Residential Development, Aderrig Phase 2, Adamstown, Co. Dublin

Stage 2 Road Safety Audit

Quintain Developments Ireland Ltd

October 2022

2.2. Problem: Formal Crossing Facilities vs Pedestrian Desire Line

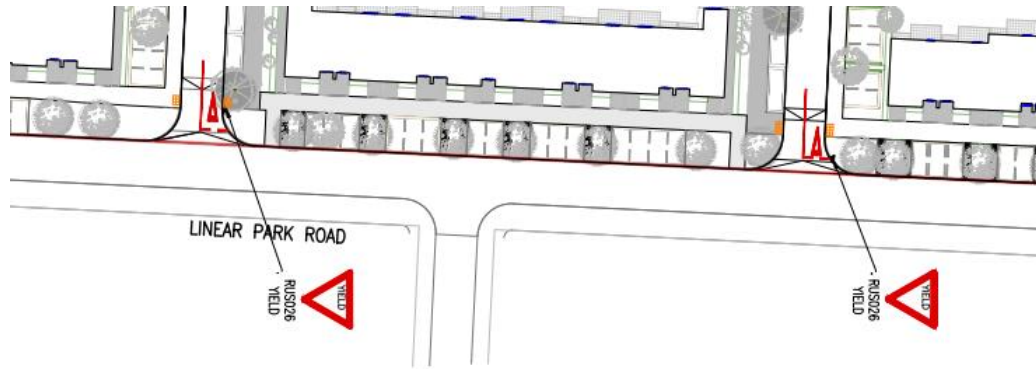
Location: Linear Park Road

Given there is an apparent pedestrian desire line between the proposed development to the west of Linear Park Road and the linear park to the east, the proposed design does not make any provision for formalised crossing facilities to accommodate safe access to the parkland area. Where no formal crossing facilities are provided, pedestrians may attempt to cross the road in an area where it is unsafe to do so leading to an increased risk of pedestrian-vehicle conflicts.

The Design Team should include provision of formalised crossing points along Linear Park Road. Such provision should be consistent with others provided in the area for similar road type and posted speed limits.

2.2	Yes	Yes	Please see attached Waterman Moylan Layout No. 20-108-C112-proposed Road Markings & Signage. This layout has been updated to include tactile paving along the Linear Park Road.

2.3. Problem: Visibility at Junctions

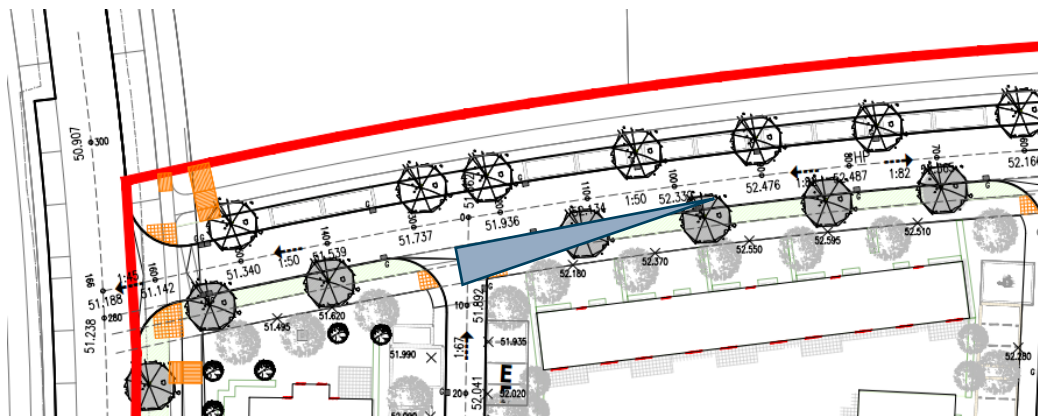
Location: General / All junctions

Where proposed landscaping measures are located in the vicinity of proposed junctions, there is potential for landscape elements (e.g. shrubs, trees, etc) to encroach into visibility envelopes over time. Where visibility at junctions is compromised / reduced, there is increased risk of side swipe type vehicle-vehicle collisions or cycle-vehicle collisions where vehicles emerging from the minor road have inadequate visibility to approaching traffic.

The Design Team should ensure that all landscaping elements are located away from junctions / visibility splays.

2.3	Yes	No	Please see attached Landscape Architects Layout No. 17-064_LD-05-CS and 17-064_HW-01-CS. These layouts show that the tree detail has a narrow stem with a 2-metre clearance to ensure visibility is unobstructed.	Yes

2.4. Problem: Access for Larger Vehicles

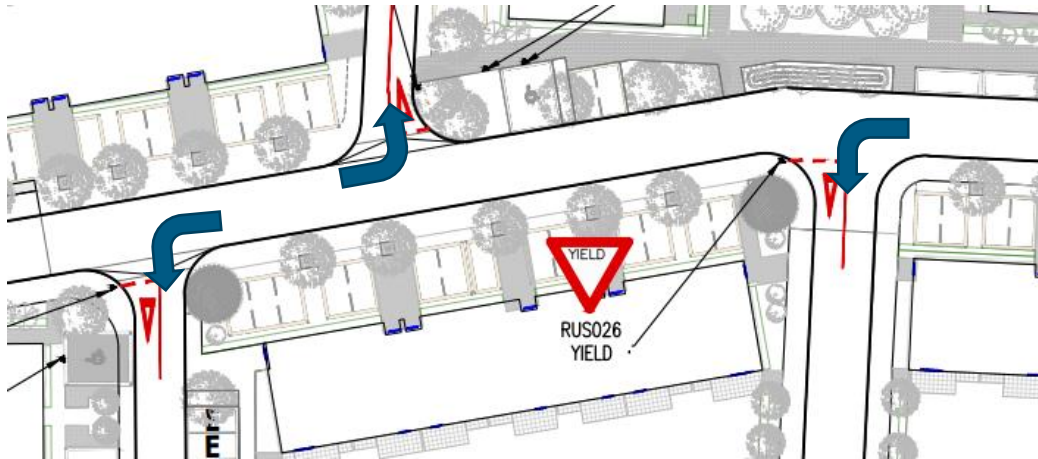
Location: Homezone Streets and Side Streets

Where access is required by larger vehicles (e.g. service vehicles [refuse truck] or emergency vehicles) the junction radii provided indicate that some turning movements may require the vehicle to mount footpaths when turning into homezone or side streets. This may lead to an increased risk of head-on type vehicle-vehicle collisions or larger vehicles being required to traverse pedestrian areas increasing the risk of vehicle-pedestrian collisions.

The Design Team should consider design measures or other alternative measures as appropriate to ensure such vehicles can safely pass through these junctions. It is recommended that swept path analysis be carried out.

2.4	Yes	Yes	Please see attached Atkins Layouts No. 5150924-HTR-10-DR-0125 to 5150924-HTR-10-DR-0129. These layouts have been prepared to show swept path movements for heavy vehicles through the development.

2.5. Problem: Visibility to Traffic Signals

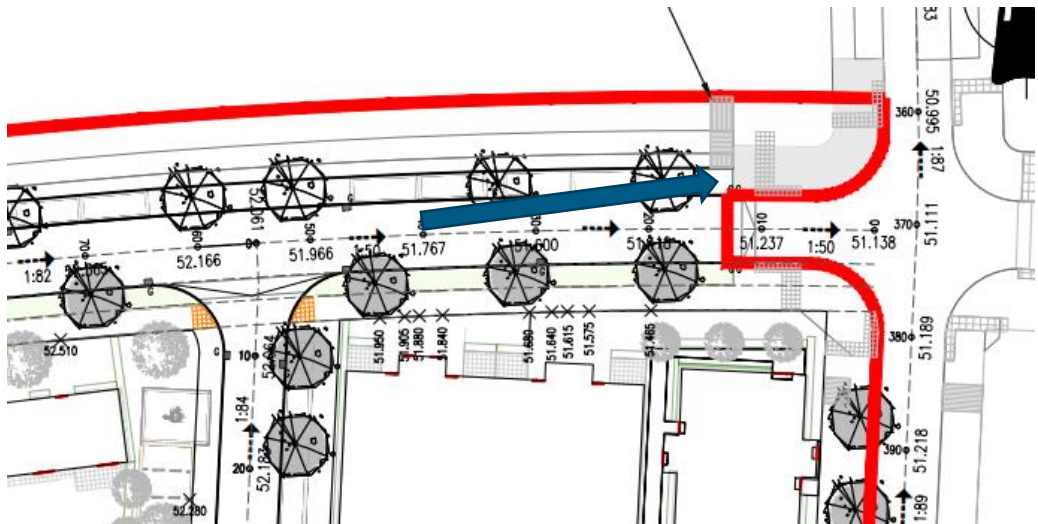
Location: Junction at NE Corner of Site

Where proposed landscaping measures are located in the vicinity of proposed junctions, there is potential for landscape elements (e.g. shrubs, trees, etc) to block visibility to traffic signals. Where visibility to traffic signals is compromised / reduced, there is increased risk of rear end, side swipe or head on type vehicle-vehicle collisions or cycle-vehicle collisions.

The Design Team should ensure that all landscaping elements do not block visibility to traffic signals.

2.5	Yes	No	Please see attached Landscape Architects Layout No. 17-064_LD-05-CS and 17-064_HW-01-CS. These layouts show that the tree detail has a narrow stem with a 2-metre	No - minimum mounting height of a standard signal head is 2.1m, the designer should clearly demonstrate that the proposed landscaping elements do not block visibility to the signals.

clearance to ensure visibility is unobstructed.
